KANSAS CITY DOWNTOWN AIRPORT – WHEELER FIELD

Master Plan
Comparative Safety Assessment Report

COMPARATIVE SAFETY ASSESSMENT

August 5, 2024

Element 1: Hot Spot #1 and Taxiway M

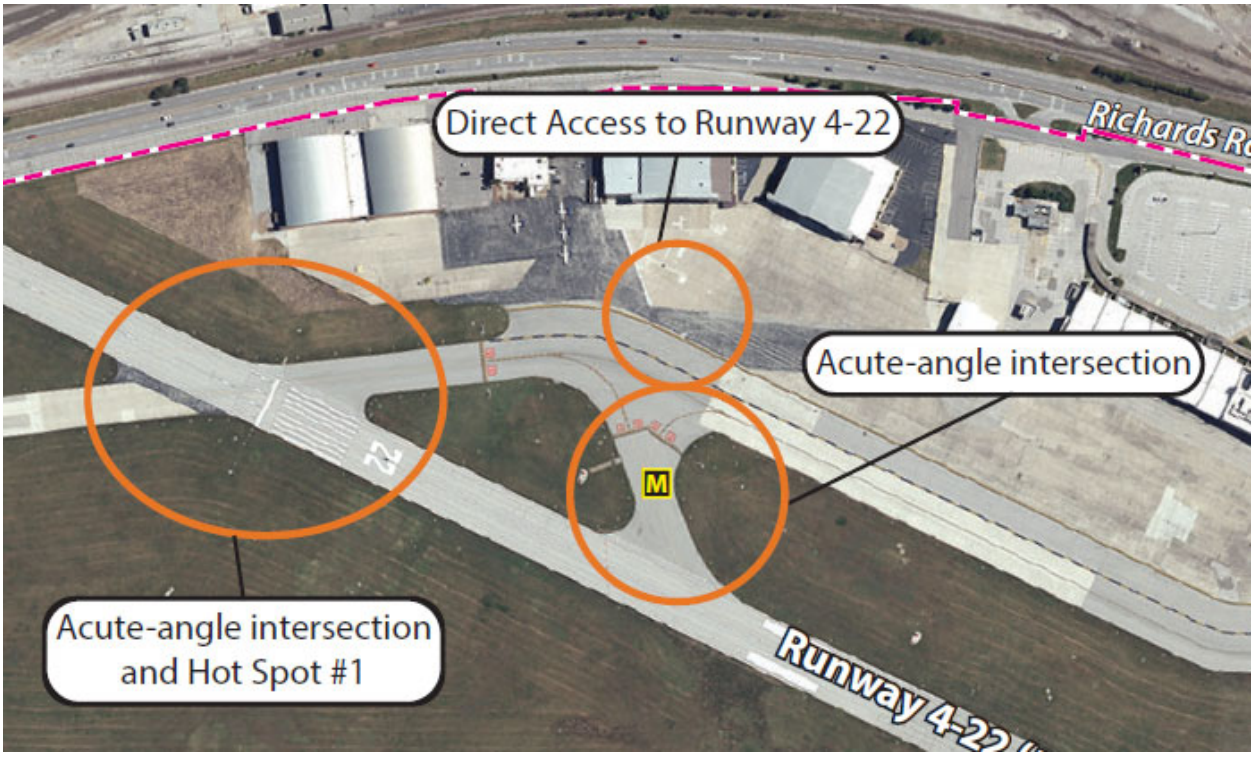
The Taxiway G and Runway 4-22 intersection is unusual due to the angle of intersection. Wide expanses of pavement at taxiway entrances and taxi paths that provide direct access to a runway can lead to loss of situational awareness for pilots and vehicle operators, which increases the risk of a runway incursion. Taxiway M provides direct access to the Runway from an Apron.

- The increased number of aircraft turns required in each of the proposed alternatives is a concern for pilots and controllers alike.
- The increased number of runway crossings by pilots increases the possibility of a runway incursion.
- Potential negative impact by snow removal activities as plows could be in the RSA for both runways, which would require closing the both runways for a longer period of time during the snow removal activity.

- Increased taxi time in the instrument landing system (ILS) controlled area due to changed geometry and taxiway turns.
- The proposed taxiway geometry would cause conflict in simultaneous operations; since Runway 4 is the ILS runway and aircraft exiting Taxiway G eastbound would result in additional runway crossings.

- Additional turns could result in pilot confusion and additional required controller guidance.
- Additional turns would increase tower communications (see above).

- Many small aircraft at MKC depart from Taxiway G (intersection departure); the proposed 90-degree taxiways near Runway 22 shown on Taxiway Alternatives 2 and 3 would not impact operations significantly as more than 3,000 feet would still be available.

- On the west side, the reduced taxiway would be too tight for aircraft turns and operations.
- Flight schools need 3,000 feet for an intersection departure, which would still be available.

- Proposed change would ultimately increase runway crossings creating a new hazardous condition.
- Snow removal constraints would result from proposed taxiway changes; during snow removal, both runway(s) would need to be closed for a longer period of time. Additional runway closures would be necessary if a parallel taxiway were constructed (Alternative 3).

- Taxiway M is used frequently as a a high-speed exit.
- Removal of Taxiway M was to eliminate proximity to the proposed Taxiway in Alternative 2 and establish a standard 90-degree turn. If no change occurs, Taxiway M can remain as is.

- It may be that the number of incursions is shrinking at Hotspot #1; and perhaps the no change option is an acceptable solution. Per FAA during the last few years no runway incursions events were attributed to the hot spot (See **Sub-Appendix C**). Regardless of runway incursions, the hot spot indicator would likely remain simply to alert pilots to be extra vigilant in this area.

- None of the proposed alternatives was selected.
- No taxiway geometry changes to the current airfield configuration were recommended based on operational concerns (See General Comments).
- Participants agreed to research and add a proposed in-pavement stop bar and/or runway guard lights at the taxiway prior to the intersection of Runway 22 and Taxiway G.
- Participants agreed to include the proposed no-taxi islands as depicted in each alternative.

ALTERNATIVE 2

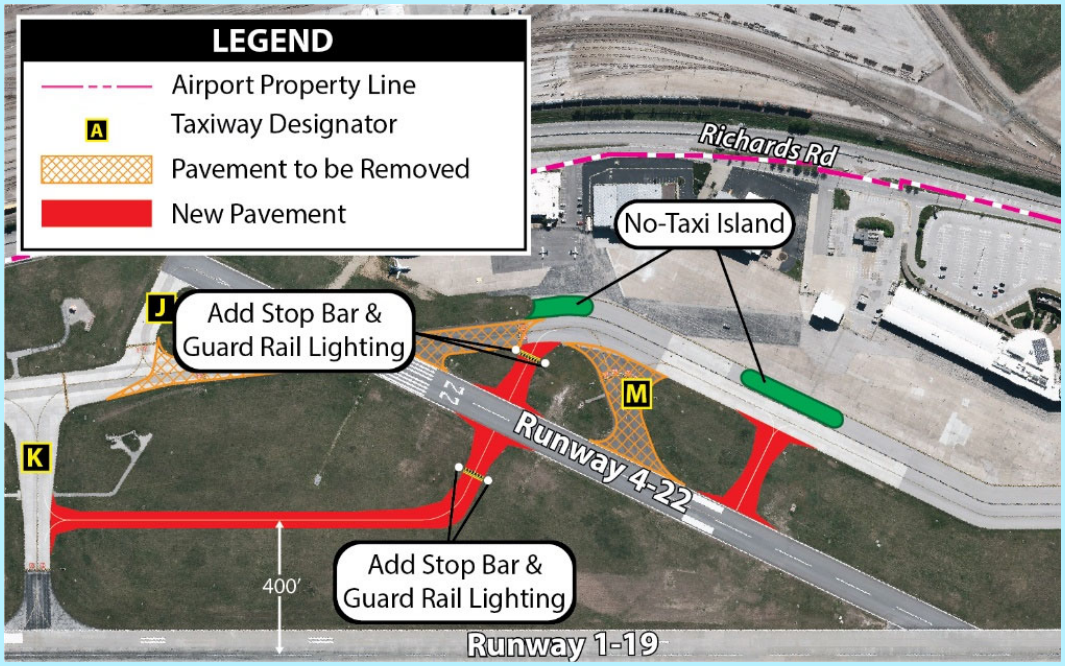
- The No-taxi island solution provides visual cues when operating on Taxiway G and Taxiway M.
- Additional stop bar and/or runway guard lights prior to the intersection of Runway 22 and Taxiway G would improve situational awareness.
- May be difficult for aircraft on Taxiway G to hold perpendicular; however hard turns would improve situational awareness.

- Alternative 2 is not ideal for similar reasons as Alternative 1 including takeoff distance, additional turns, student traffic, and snow removal constraints.
- Pilots could miss the new Taxiway G entirely when exiting Runway 1-19 at Taxiway K due to the new location of Taxiway G.
- The number of turns to taxi from ramp to the runway seems excessive. Currently the taxi route includes one turn, whereas the new alternative results in five turns.
- For aircraft operating on Runway 1 and exiting right on Taxiway K will create a conflict with aircraft coming off Taxiway K and the new proposed taxiway.
- Runway 22 is used as an exit by student pilots landing on Runway 1 because it takes too long to get to Taxiway K. This creates congestion.

ALTERNATIVE 3

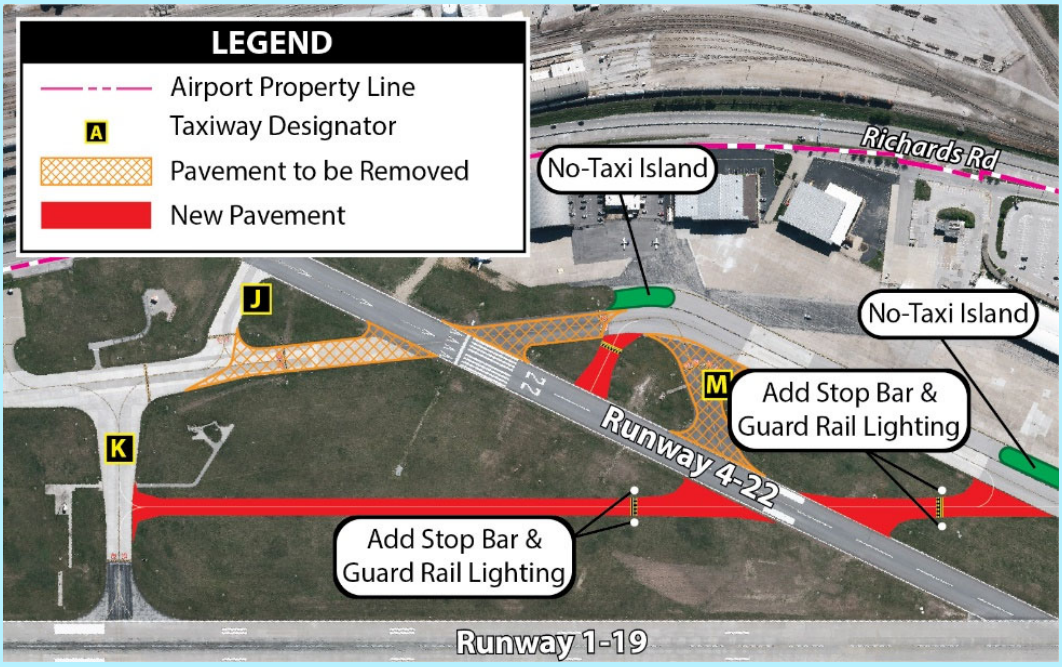
- The No-taxi island solution provides visual cues when operating on Taxiway G and Taxiway M.
- Additional stop bar and/or runway guard lights prior to the intersection of Runway 22 and Taxiway G would improve situational awareness.
- Parallel taxiway is a familiar layout for pilots.

- The proposed parallel taxiway would cross Runway 4-22 in the high-energy area (middle third of the runway). Per FAA, taxiway crossings through the high energy area are not recommended.
- If a pilot is holding short of the new Taxiway G on either side of Runway 4/-2, pilots will not be perpendicular to the runway.

Element 2: Hot Spot #2 - Taxiway D Direct Access to Runway

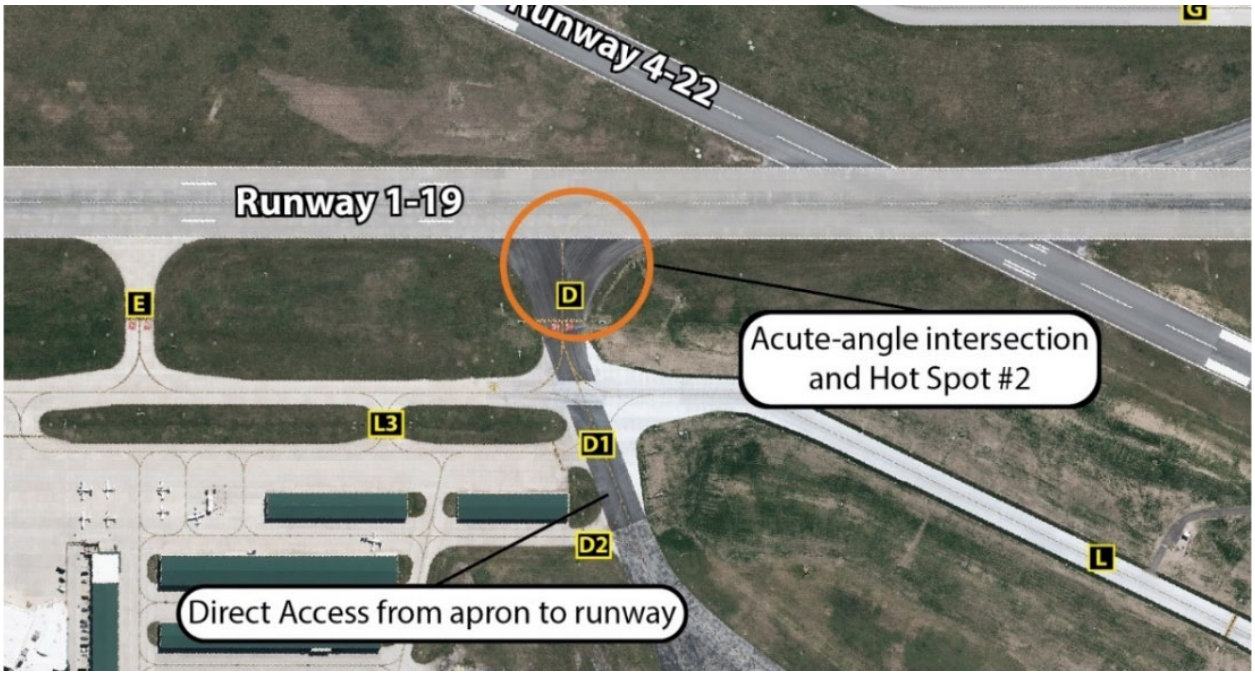
The proposed alternatives are intended to resolve a direct apron to runway access issue (taxilane leads from apron area to runway). When this was discussed previously, shifting that portion of Taxiway D between the runway and Taxiway L was not supported because it was thought that the new connection would be too close to intersection of two runways thus being potentially confusing to pilots. Taxiway D is also a wide expanse of pavement and is planned to be narrowed to a 90-degree to mitigate the existing geometry.

- Wider pavement is desired for aircraft maneuvers at the Taxiway D exit.
- Runway guard lights provide additional pilot situational awareness.

- The current use of Taxiway D is primarily for aircraft exiting Runway 1-19 for both north and south flow landings.
- Narrowing the pavement in this area would restrict aircraft movements and operations.
- Removing the wide fillets limits aircraft in back taxi operations and maneuvers.
- For aircraft attempting to exit at Taxiway D, additional pavement allows larger aircraft to make turns; otherwise, pilots need to taxi to Taxiway B which reduces capacity and requires a runway crossing.
- Medevac aircraft also require the additional pavement which would impact on their operations.
- The Airport needs to balance uniform taxiways and standards with operational benefits including wider taxiways in some areas; this could be considered in the future.
- A larger taxiway separation from runway intersections is beneficial for pilot situational awareness.

Alternative 2 was selected as the preferred option.

ALTERNATIVE 1

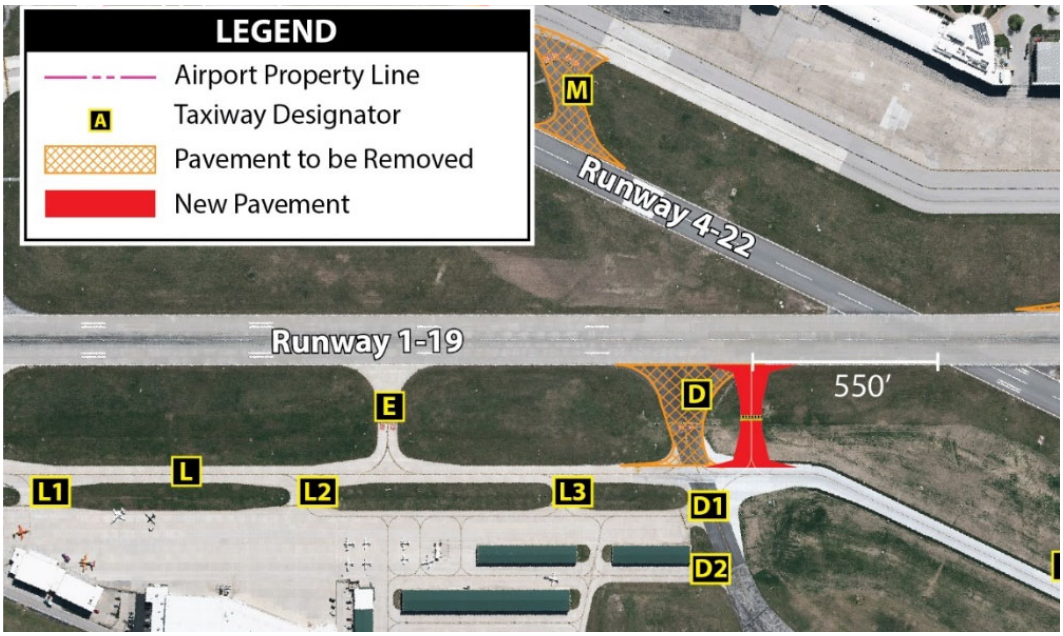
- Provides standard 90-degree taxiway angle.
- Wide taxiway preferred for turning larger aircraft.
- Spacing among Taxiways K, E, and D becomes more uniform.
- Provides a larger separation from the runway intersection.
- Removes direct access issue.

- Moving Taxiway D to the south makes it less usable as an exit when landing from the south.
- Reduces operational efficiencies.

ALTERNATIVE 2

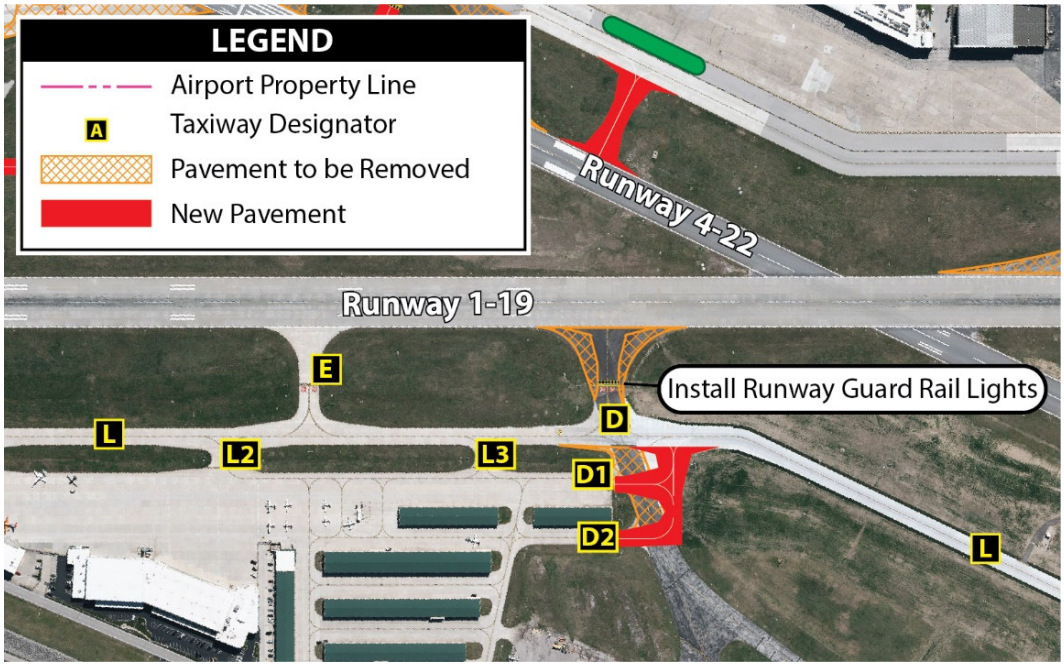
- Provides standard 90-degree taxiway angle.
- Removes direct access issue.
- If the primary reconstruction of Taxiway D occurs on the west side of Taxiway L, then the amount of time for runway closure will be reduced.
- Improves the line of sight for the tower for aircraft departing the T-hangar area.
- Some adjustment to the pavement (angled, not 90, wide flare) will be planned; however, a case could be made that Taxiway D could be wider. (See General Comments)
- Runway guard lights provide additional pilot situational awareness.

- Feedback from the CSA committee indicated a concern for narrowing Taxiway D between Runway 1-19 and Taxiway L as large business jets use this exit and aircraft may benefit from a wider than standard width.
- Shifting the west portion of Taxiway D would slightly reduce the area available for hangar development.

SELECTED ALTERNATIVE

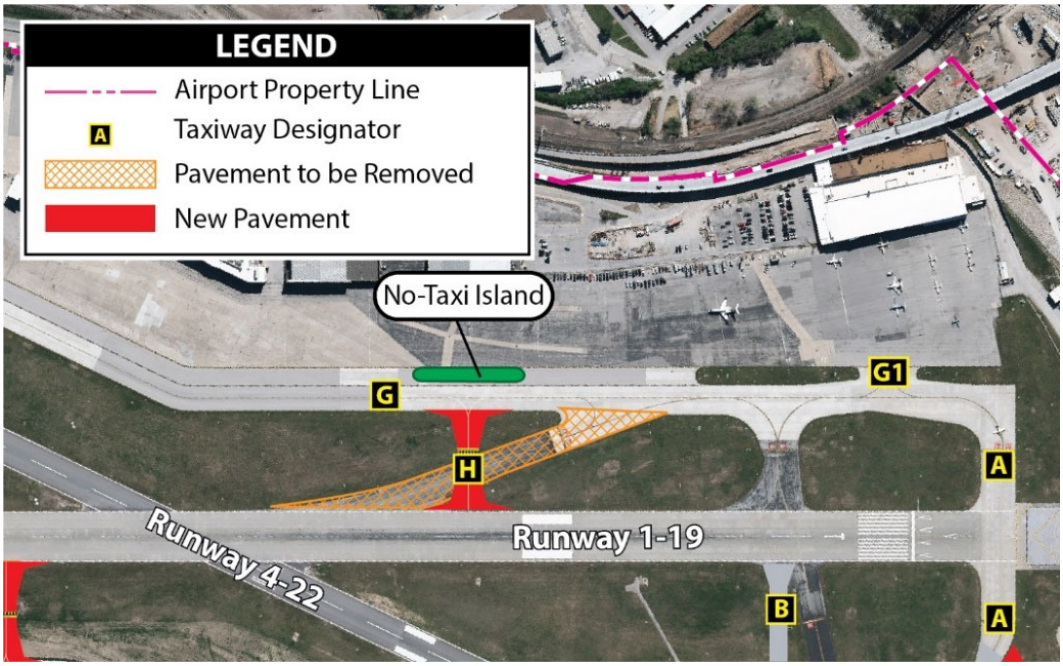
- Taxiway H is the most used exit in MKC south flow operations on the east side of the field; most jets are exiting at Taxiway H.
- The existing exit is in the optimal location.
- The current condition provides an ideal flow to east side FBO facilities.
- A 30-degree taxiway angle modification will not impact existing operations.
- A 90-degree taxiway will increase delays and decrease efficiencies.

Alternative #3 was selected as the preferred option.

ALTERNATIVE 3

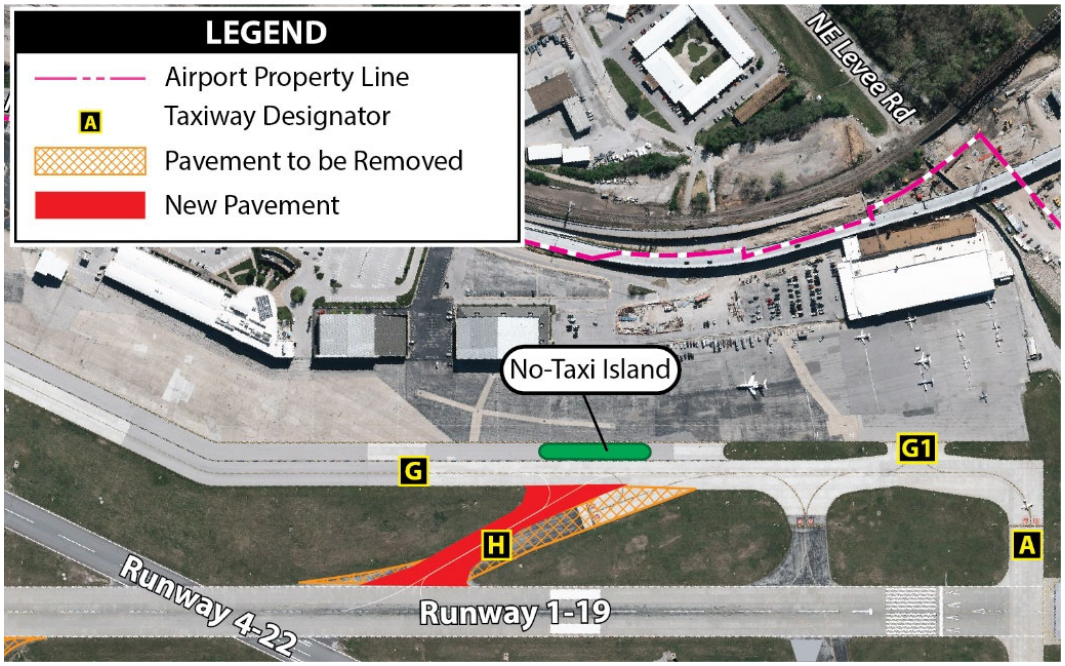
- Enhances runway capacity by reducing runway occupancy times.
- Continues to provide high-speed exit for south flow operations.
- No-taxi islands are included to prevent direct access from an apron area to a runway.

When it is time for Taxiway H to be reconstructed due to normal use, Taxiway H would be reconstructed at the standard 30-degree angle.

Element 4: Southwest Landside Alternatives Unconstrained by Existing Lease Lines

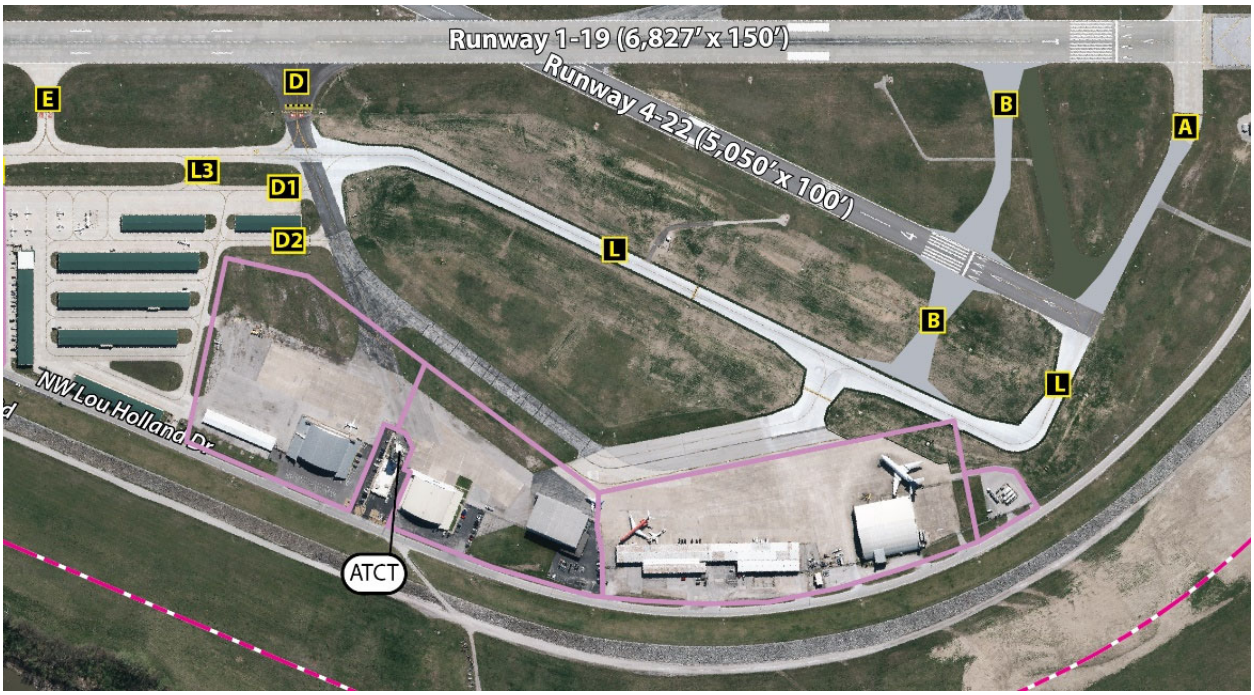
SAFETY CONCERN(S):
Areas shaded in red are locations that would not be visible from the cab to the ground. The viewshed analysis for each southwest landside alternative is shown in the second figure of each alternative. Additionally, the existing Taxiway F will no longer serve as a taxiway under FAA ATCT control and will be separated by a roadway that enters the area from Lou Holland Drive.

- Alternatives #1, #2, and #3 were not considered due to participant consensus that existing lease lines were to be maintained.
- Line of sight (viewshed review) was the most critical decision factor for alternative selection.
- Loss of Taxiway F as the primary taxi route into the area is managed by the implementation of Taxiway L as a replacement alternative.
- Segregating the development area with a roadway is required to provide access to the new facilities.
- Preserving existing lease lines will allow for existing facilities to maintain operations in a single area.
- In Alternative #4, Taxiway L is visible but small portions of the taxiway object free area (TOFA) would be blocked. The height of the proposed hangars could be lowered to make the entire TOFA visible; however, Alternative #5 does not require modifications and thus is a better alternative.

- **Alternative #5** was selected as the preferred option. See alternatives #4 and #5 for details.
- General comments are listed after Alternatives #4 and #5.

ALTERNATIVE 1

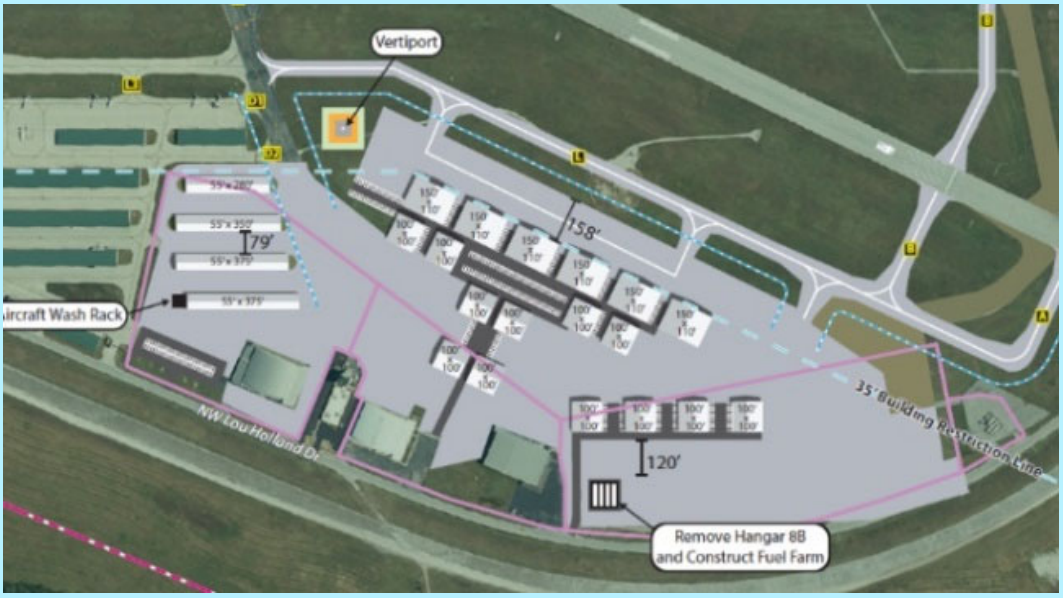
- Alternative #1 was not considered

ALTERNATIVE 2

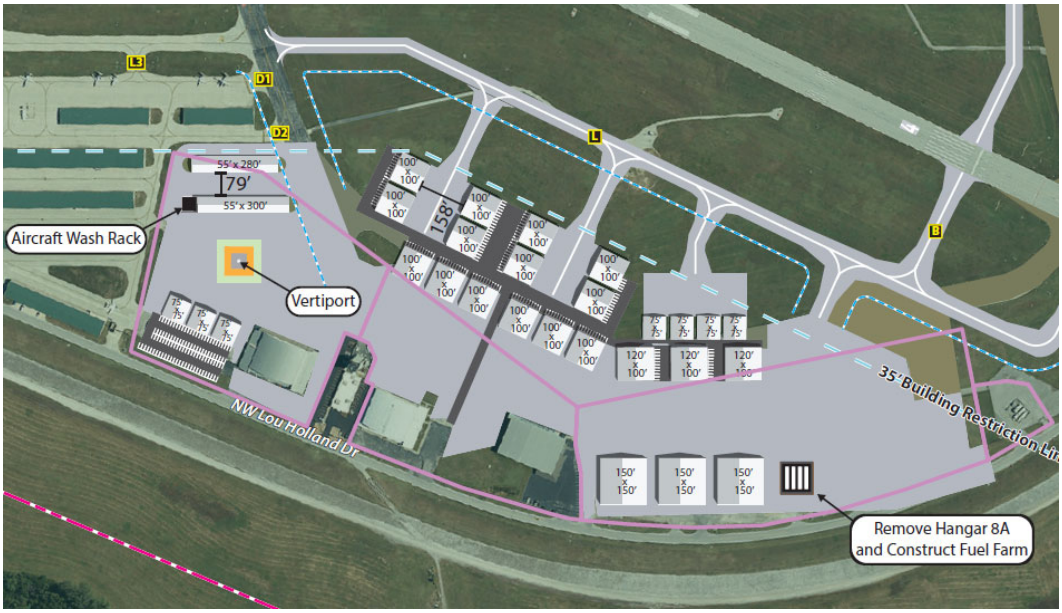
- Alternative #2 was not considered
